COMMONWEALTH OF KENTUCKY TRANSPORTATION CABINET

CONTRACT ID NO. 182410

ADDENDUM # 1

Subject: BARREN COUNTY, FD05 005 0090 000-004

Contract ID: 182410 Page 38 of 55 REVISED ADDENDUM #1: 11-29-18

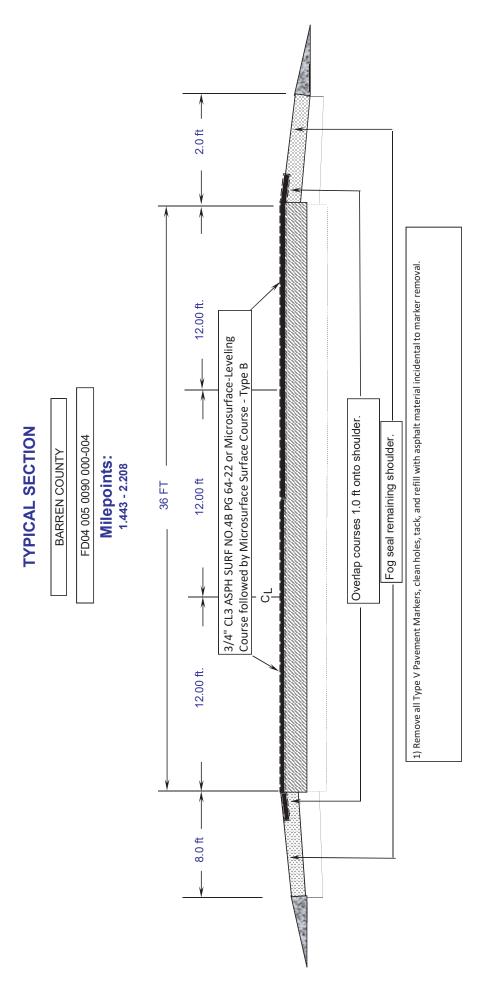
- (1) Revised Summary Sheet Page 9 of 55
- (2) Revised Detail Sheets Pages 37-39 of 55
- (3) Revised Proposal Bid Items Page 55 of 55
